Model: Soleil-PJ1a/Soleil-PJ1b/Soleil-PJ2/ Altair-PJ1/ Altair-PJ2/Soleil-PJ2.5	Date: 19-Oct-12	No.: RY011003f
---	-----------------	----------------

Subject: Firmware Release Note: Backup Tool		Prepared by: A. Iwaori	
From: VC Products Support Sec., Solution Support Dept.			
Classification:	<input type="checkbox"/> Troubleshooting <input type="checkbox"/> Mechanical <input type="checkbox"/> Paper path <input type="checkbox"/> Product Safety	<input type="checkbox"/> Part information <input type="checkbox"/> Electrical <input type="checkbox"/> Transmit/receive <input checked="" type="checkbox"/> Other (Firmware)	<input type="checkbox"/> Action required <input type="checkbox"/> Service manual revision <input type="checkbox"/> Retrofit information <input checked="" type="checkbox"/> Tier 2

Model: Soleil-PJ2a/b		Date: 30-May-16	No.: RY033003
Subject: Service manual revision: Keystone Calibration & Troubleshooting		Prepared by: Takuma. Sakakibara	
From: VC Tech Service Sect., MFP/Printer Tech Service Dept.			
Classification:	<input type="checkbox"/> Troubleshooting <input type="checkbox"/> Mechanical <input type="checkbox"/> Paper path <input type="checkbox"/> Product Safety	<input typ

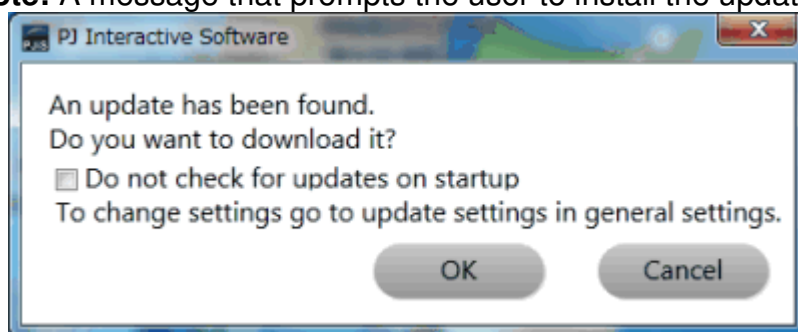
Remote whiteboard sharing does not start under the following conditions:

- Software v1.2.2.0 or earlier
- The software is installed in a language other than Japanese
- JAVA_HOME is not pre-configured in the System Properties in Windows.
(System Properties - Advanced System Settings - Advanced - Environment Variables - System variables)

Update the software to **v1.2.3.0** or later.

Step 4.

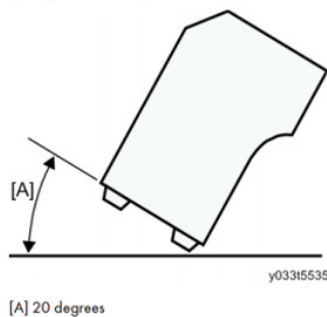
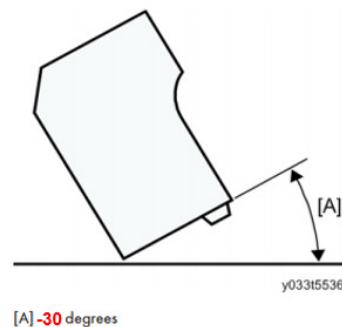
4. Keep the projector at 20 degrees.
When the adjustment is successfully completed, the values changes from the default [0-0-2048].
(Example: See below)

Wrong

4. Keep the projector at **-30** degrees after removing the stand in the front of projector.

Correct

Step 7.

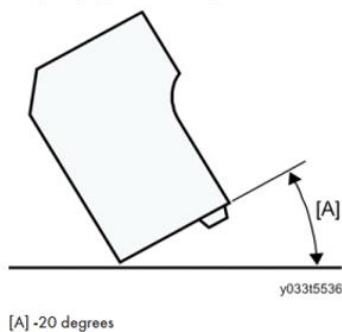
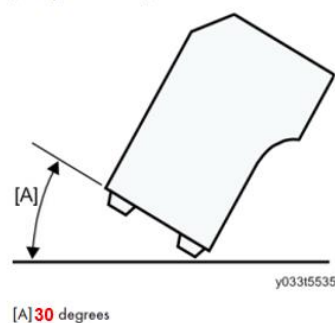
7. Keep the projector at -20 degrees after removing the stand in the front of projector.

Wrong

7. Keep the projector at **30** degrees.
When the adjustment is successfully completed, the values changes from the default [0-0-2048].
(Example: See below)

Correct
